HILLTOP SUBDIVISION, FIRST ADDITION TO, RESUBDIVISION OF LOT 1, BLOCK "A"

APPLICATION NUMBER 3 DATE February 15, 2023

REQUEST Subdivision

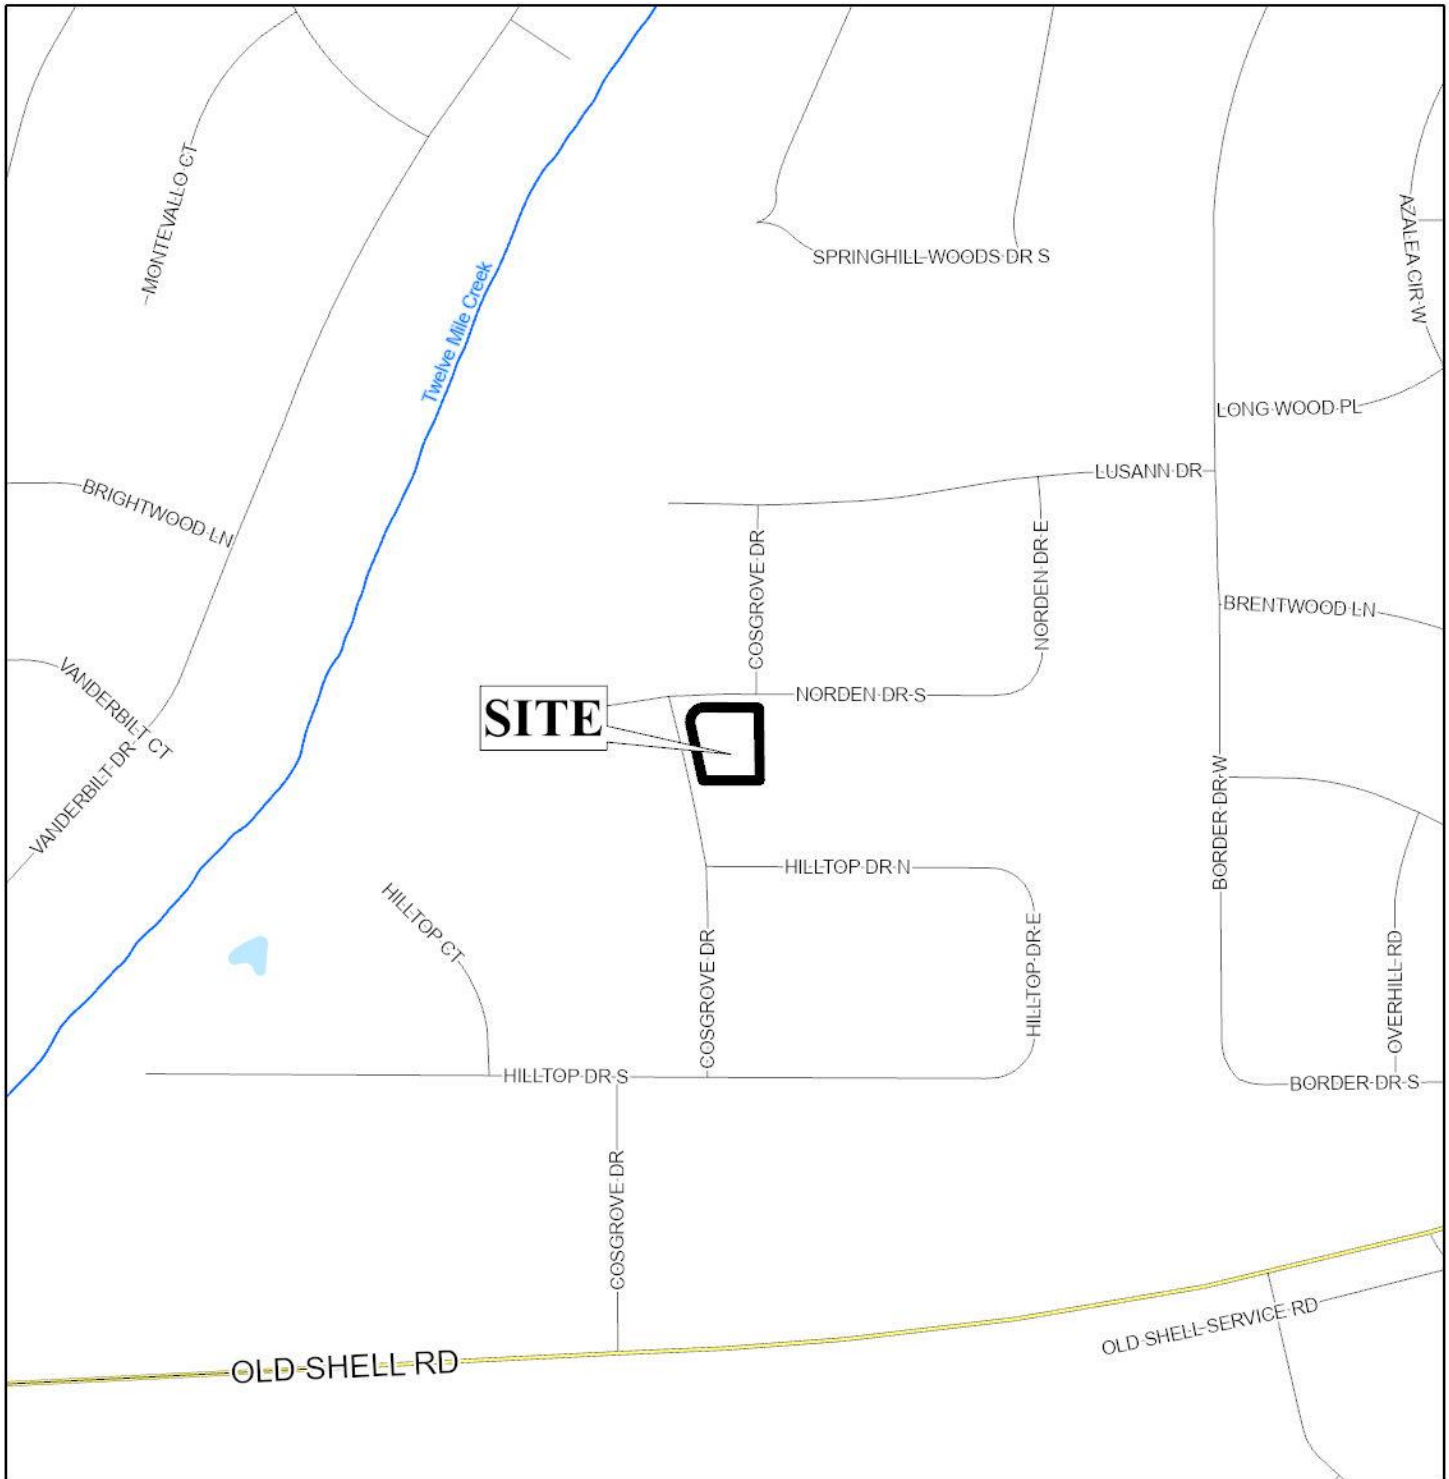
The proposed site has frontage on Cosgrove Drive, a minor street with curb-and-gutter requiring a 50-foot right-of-way, and Norden Drive South, a minor street with curb-and-gutter requiring a 50-foot right-of-way. The preliminary plat illustrates an existing compliant 50-foot right-of-way for both streets at this location; thus, no additional dedication is required. As on the preliminary plat, the right-of-way widths of Cosgrove Drive and Norden Drive South should be retained on the Final Plat, if approved.

The preliminary plat submitted indicates an existing 25-foot minimum building setback line along Cosgrove Drive, which meets the minimum building setback line required by Section V.D.9 of the Subdivision Regulations. The preliminary plat submitted illustrates a 20-foot minimum building setback line along Norden Drive South as allowed by 64-4.D.3. of the Zoning Ordinance, as it is the side street for the subject site. If approved, the 25-foot minimum building setback lines along Cosgrove Drive should be retained on the Final Plat. With a waiver of Section V.D.9 of the Subdivision Regulations, the 20-foot minimum building setback line along Norden Drive South should be illustrated on the Final Plat.

The lot exceeds the minimum size requirements of the Subdivision Regulations, and the lot size should be retained in square feet and acres on the Final Plat, if approved.

There is a 7.5-foot drainage and utility easement illustrated along the East property line of the proposed subdivision. If approved, a note should be placed on the Final Plat stating that no structures shall be constructed in any easement without permission of the easement holder.

With a waiver of Section V.D.9. of the Subdivision Regulations, the submitted plat meets the minimum requirements of the Subdivision Regulations and is recommended for Tentative Approval subject to the following conditions:

- 1) Retention of the right-of-way widths of Cosgrove Drive and Norden Drive South on the Final Plat;
- 2) Retention of the 25-foot minimum building setback line along Cosgrove Drive;

- 3) Placement of a note on the Final Plat illustrating a 20-foot setback along Norden Drive South;
- 4) Retention of the lot sizes in square feet and acres on the Final Plat;

- 5) Placement of a note on the Final Plat stating that no structure shall be constructed in any easement without permission of the easement holder;
- 6) Compliance with the Engineering comments: *(FINAL PLAT COMMENTS (should be addressed prior to submitting the FINAL PLAT for review and/or signature by the City Engineer): A. Provide all of the required information on the SUBDIVISION PLAT (i.e. signature blocks, signatures, certification statements, written legal description, required notes, legend, scale, bearings and distances) that is required by the current Alabama State Board of Licensure for Professional Engineers and Land Surveyors. B. Add a note to the SUBDIVISION PLAT stating that as shown on the 1984 aerial photo (FLIGHT 21 - #73) LOT A will receive the historical credit of existing (1984) impervious area towards stormwater detention requirement per Mobile City Code, Chapter 17, Storm Water Management and Flood Control) as follows: LOT A – 2,500 sf. C. Add a note that a Land Disturbance permit will be required for any land disturbing activity in accordance with Mobile City Code, Chapter 17, Storm Water Management and Flood Control); the City of Mobile, Alabama Flood Plain Management Plan (1984); and, the Rules For Erosion and Sedimentation Control and Storm Water Runoff Control. D. Add a note that the approval of all applicable federal, state, and local agencies (including all storm water runoff, wetland and floodplain requirements) will be required prior to the issuance of a Land Disturbance permit. E. Add a note that sidewalk is required to be constructed, and/or repaired, along the frontage of each lot, or parcel, at time of new development or construction, unless a sidewalk waiver is approved. F. Add a note that all existing and proposed detention facilities, common areas, and wetlands shall be the responsibility of the Property Owner(s), and not the responsibility of the City of Mobile. G. Add a note that all easements shall remain in effect until vacated through the proper Vacation process. H. Email a pdf copy of the FINAL SUBDIVISION PLAT and LETTER OF DECISION to the Permitting Engineering Dept. for review at land.disturbance@cityofmobile.org prior to obtaining any signatures. No signatures are required on the drawing.*

DETAIL SITE PLAN

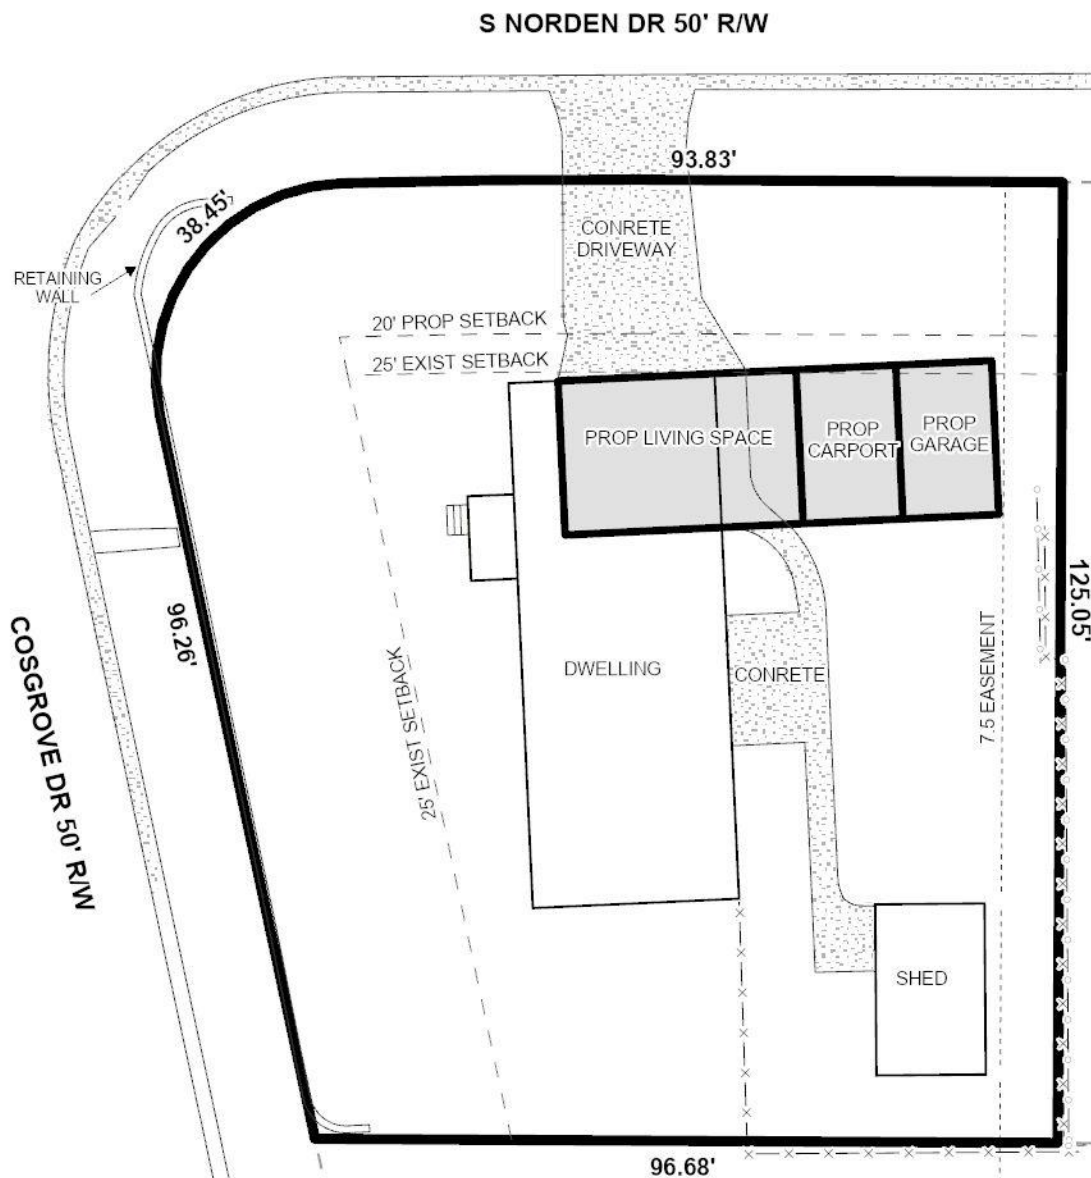
The subject property is located at the southeast corner of Cosgrove Drive and South Norden Drive. The existing dwelling faces Cosgrove Drive, which is the primary frontage. The driveway entrance and carport are located on the South Norden Drive side of the lot. As is evident from the drawing, the existing dwelling was not constructed parallel with either road frontage. The dwelling is positioned on the lot with a slight rotation.

The owner desires to close in the carport and an additional 8 feet east of the carport to increase the living space of the dwelling. Additionally, a single-car carport and a single-car garage are proposed to be constructed east of the new living space. The proposed additions, extending eastward from the northeast corner of the dwelling, will violate the 25-foot minimum building setback due to the rotated position of the dwelling on the lot.

The purpose of this subdivision application is to modify the 25-foot minimum building setback to be a 20-foot minimum building setback on the South Norden Drive side of the lot.
